# Updates to the Text for the Draft for Energy Efficient Ethernet and LPI Signalling

Philip Curran  
Brian Murray  
Jacobo Riesco

- ▶ This presentation presents an update to the text for Energy Efficient Ethernet and LPI Signalling required for the draft
  - There have been a number of presentations on EEE, all of which generally follow the scheme of clauses 149 and 165

Figure 190–11—LPI signal timing

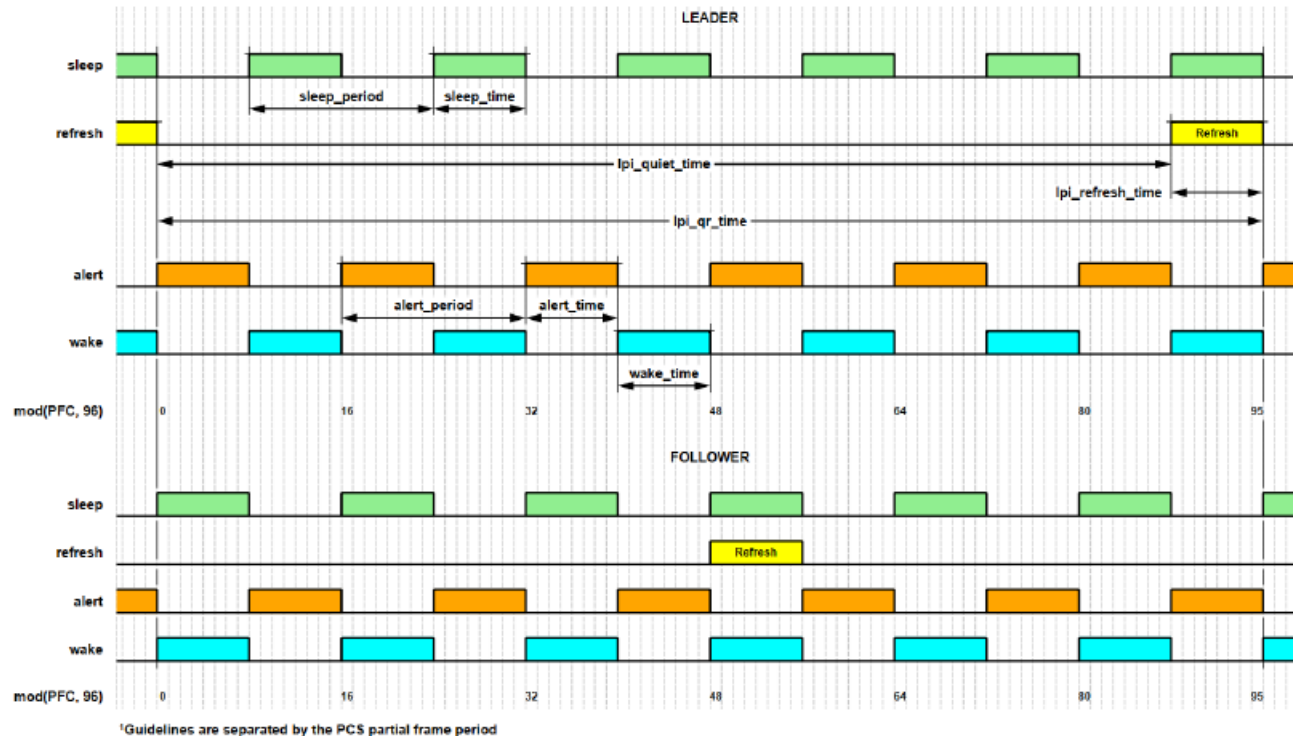
- ▶ The signal timing is shown in [Figure 190–11—LPI signal timing](#)
  - The PHY uses a repeating quiet-refresh cycle using the LPI timing parameters are in [Table 190–8](#)
  - The timing parameters are all integer multiples of the PCS partial frame period
  - The LEADER and FOLLOWER refresh periods and alert windows are offset

Figure 190–12—PCS (8N)B/(8N + 1)B Transmit state diagram

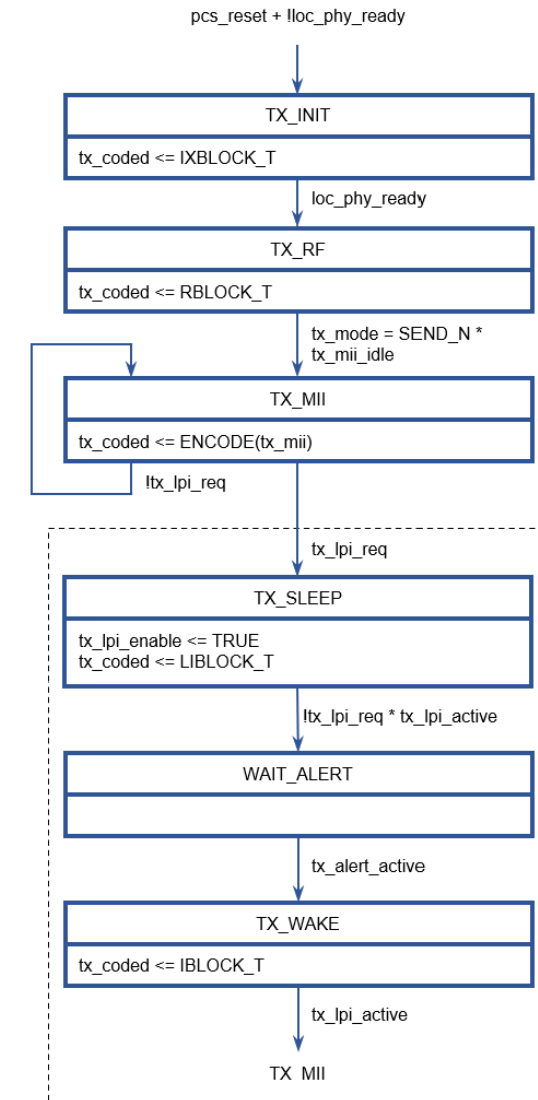
- The variable **tx\_lpi\_req** is defined differently from clause 149

- The variables **eee\_low\_snr** and **rem\_eee\_low\_snr** are included in the generation of **tx\_lpi\_req**
- The variable **tx\_lpi\_enable** now drives the operation of the EEE transmit state diagram
- No /LI/ control symbols are sent to the line until this state diagram enters TX\_SLEEP
  - Once this state diagram enters TX\_SLEEP a complete sleep signal will be sent
- In previous clauses the state diagram can transition from TX\_SLEEP to TX\_WAKE as soon as transmission of the sleep signal begins
  - This has been resolved by introducing the WAIT\_ALERT state

Boolean variable that is set TRUE when EEE is enabled for the link, and **eee\_low\_snr** is FALSE, and **rem\_eee\_low\_snr** is FALSE, and 2N + 8 consecutive MII transfers, including the 2N transfers represented by the elements of the **tx\_mii** array, indicate Assert LPI. It is set FALSE otherwise.

Figure 190–13A—EEE transmit state diagram

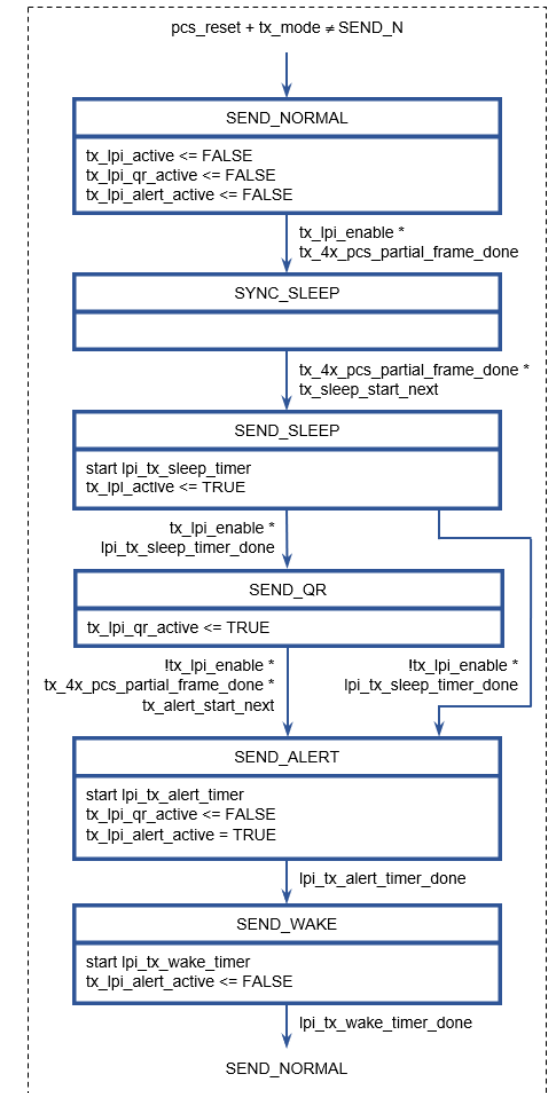
- Added SYNC\_SLEEP state to deal with transmit latency
  - All previous clauses have specified that the full sleep signal is transmitted once entry to LPI is initiated
  - But latency in the transmit path means that this is never implemented in practice

Figure 190–13B—PCS Receive state diagram, part b

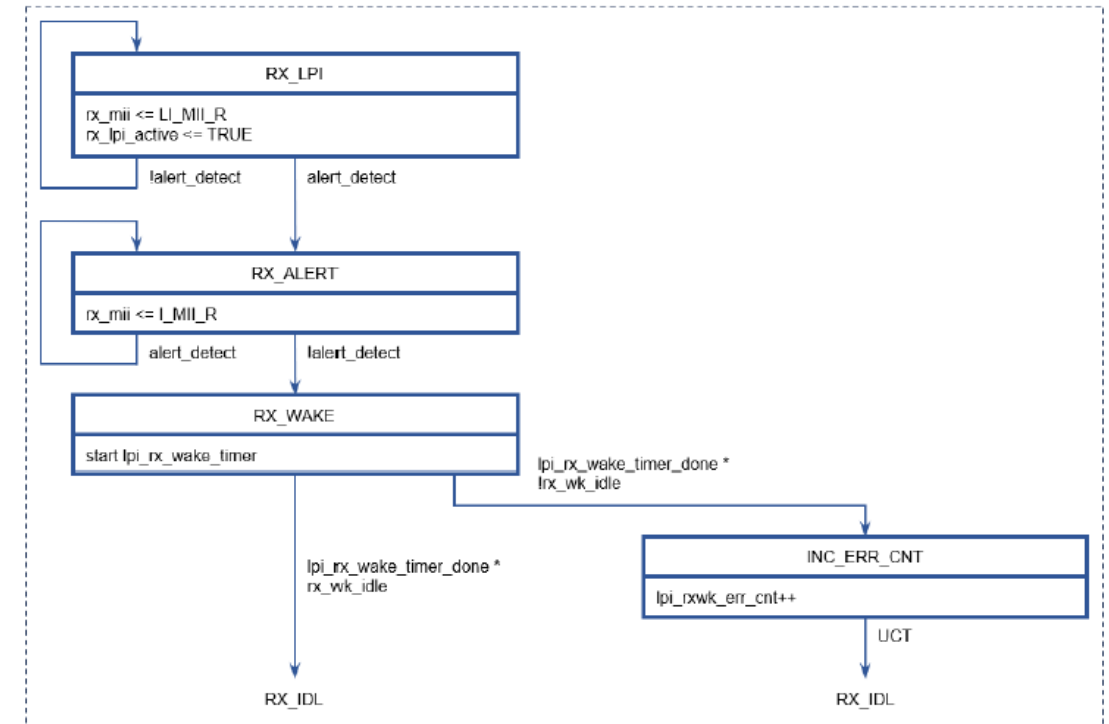
- ▶ The receive side is similar to what is done in clauses 149 / 165 with the exception that we have added the RX\_ALERT state
  - If we go directly from RX\_LPI to RX\_WAKE then by the time the **wake\_timer** expires the wake signal from the link partner may not have propagated through the receive path
    - When RS-FEC is enabled the receive path latency is very large
  - We detect that the alert signal at the PMA interface has passed and we infer that the wake signal has arrived at the PMA to PCS interface
  - The whole of the **lpi\_rx\_wake\_timer** period is available to allow for latency in the receive path

Figure 190–13B—PCS Receive state diagram, part a

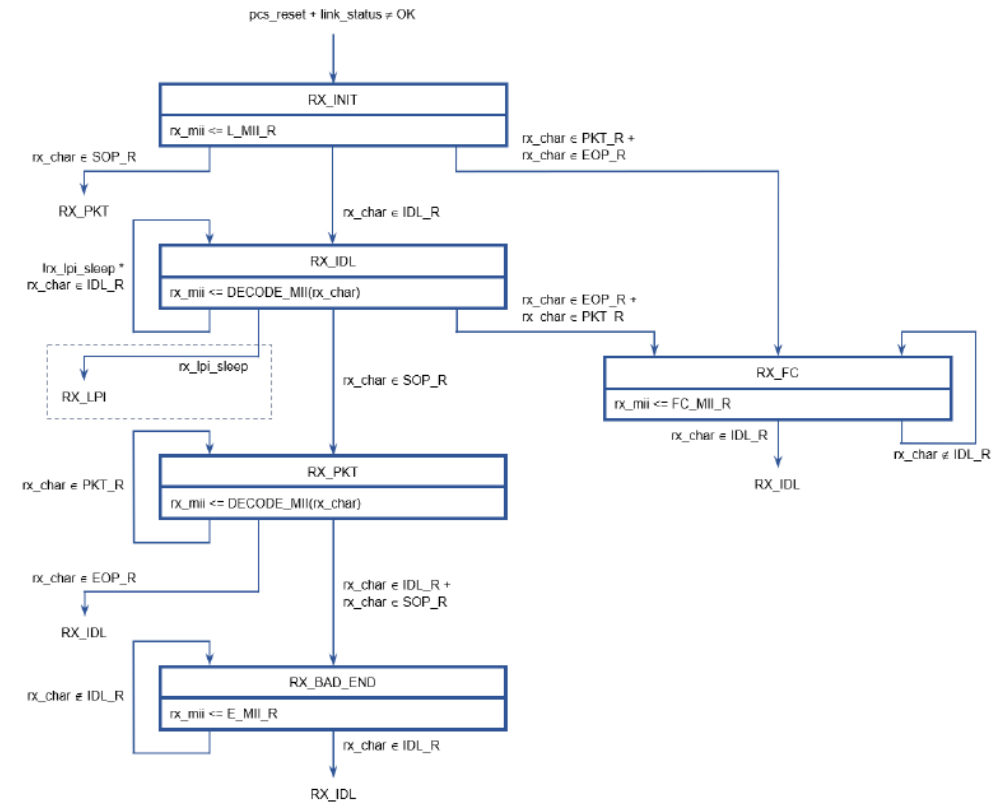
## ► Entry to RX\_LPI happens when `rx_lpi_sleep` becomes TRUE

- Hence the PCS Receive state diagram enters RX\_LPI before the sleep signal from the link partner has finished
- The sleep signal and the alert signal cannot be confused with each other, this is just by the way they have been designed

Boolean variable that is set TRUE when 32 consecutive `rx_char` values each represent /LI/. It is set FALSE otherwise.

Figure 190–11—LPI signal timing

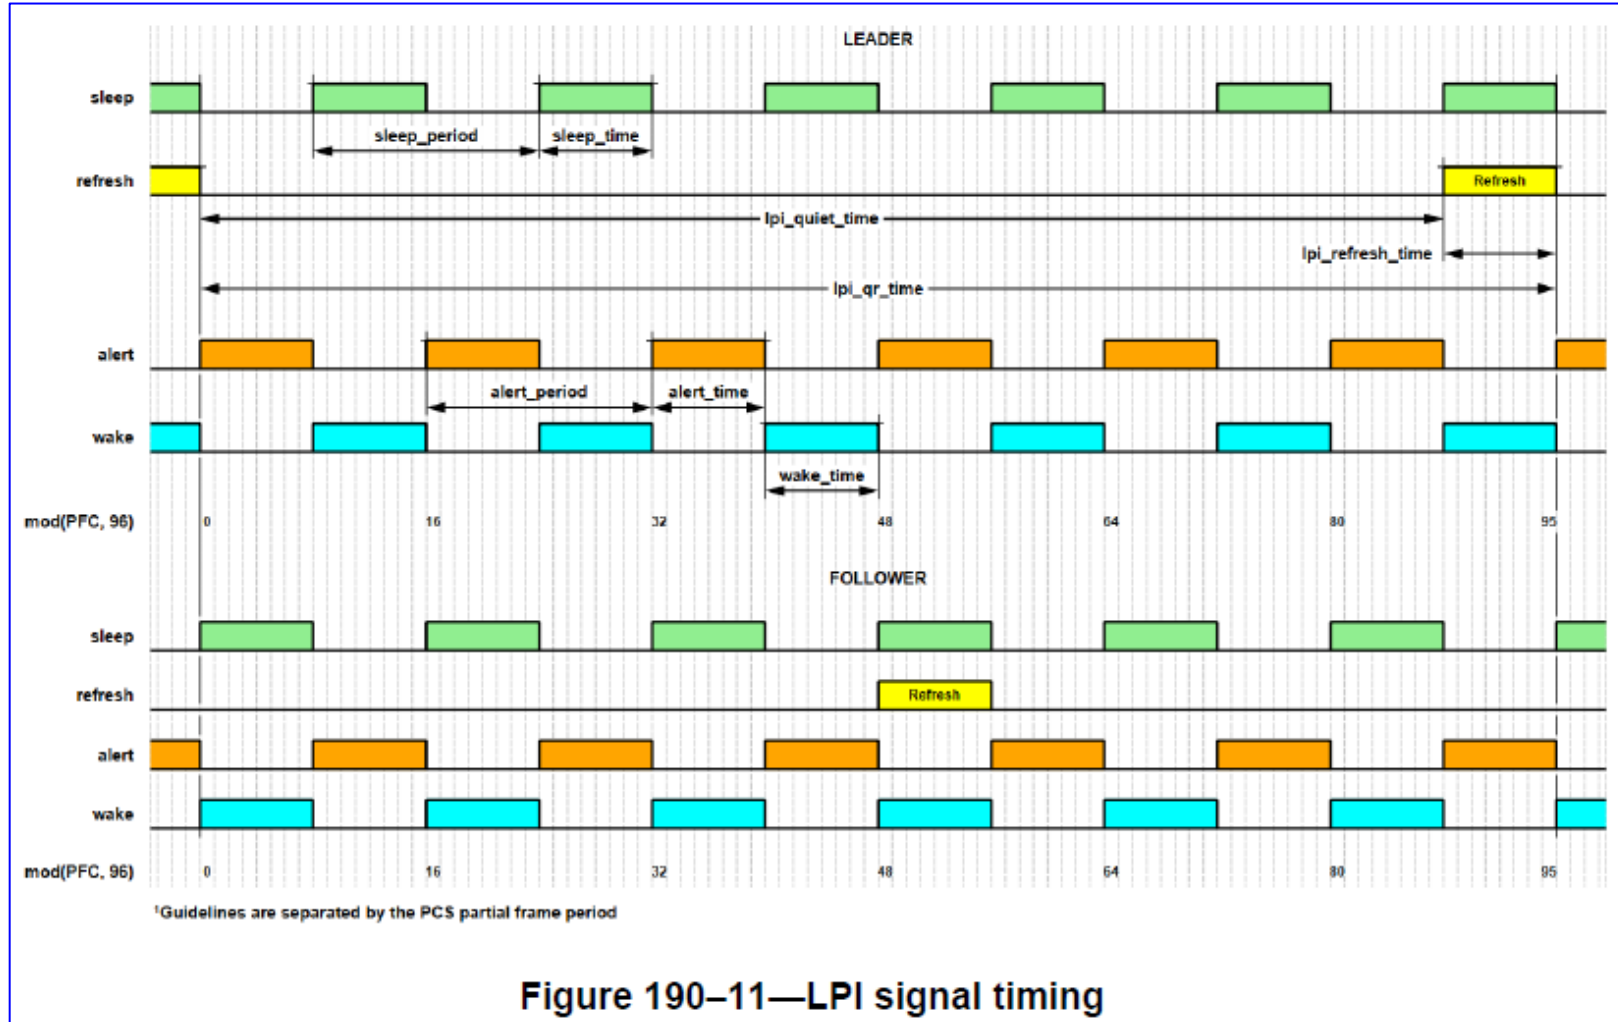
## ► Update Figure 190–11—LPI signal timing

Figure 190–12—PCS  $(8N)B/(8N + 1)B$  Transmit state diagram

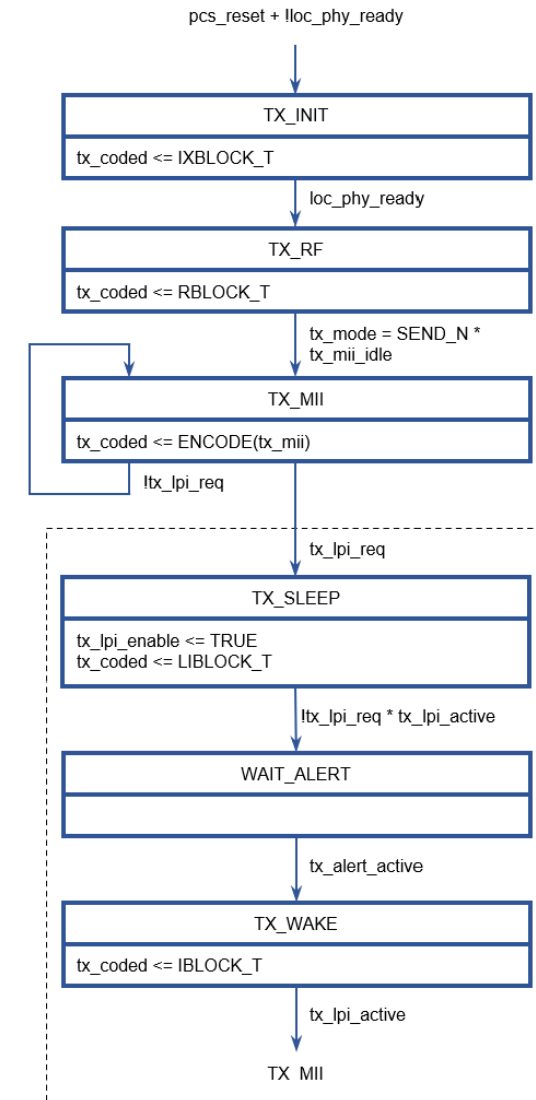
## ➤ Replace placeholder Figure 190–12—PCS $(8N)B/(8N + 1)B$ Transmit state diagram

- The variable `tx_lpi_req` is defined differently from clause 149

**Figure 190–13A—EEE transmit state diagram**

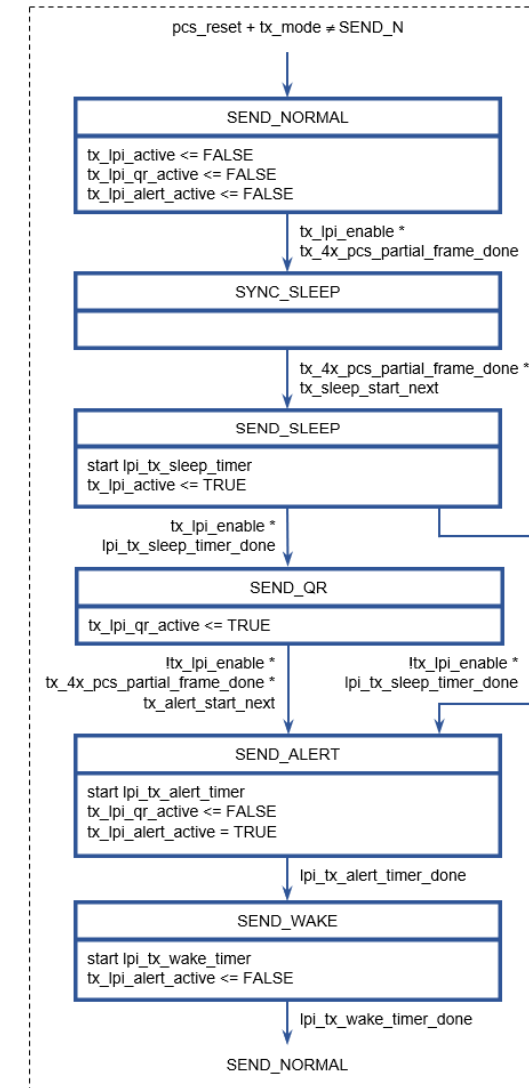
- Continue section 190.3.8.2 State diagrams
  - State Diagrams for the EEE transmit
  - New Figure 190–13A—EEE transmit state diagram

**Figure 190–13B—PCS Receive state diagram, part b**

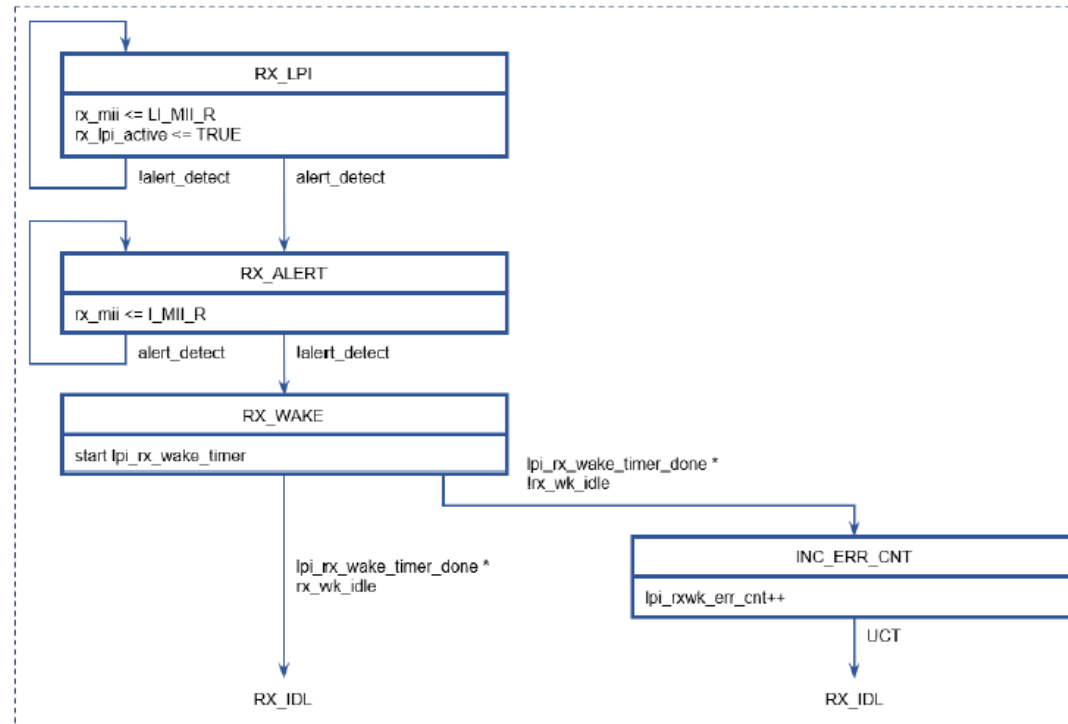
- ▶ Continue section 190.3.8.2 State diagrams
  - Continue State Diagrams for the PCS receive
  - New Figure 190–13B—PCS Receive state diagram, part b
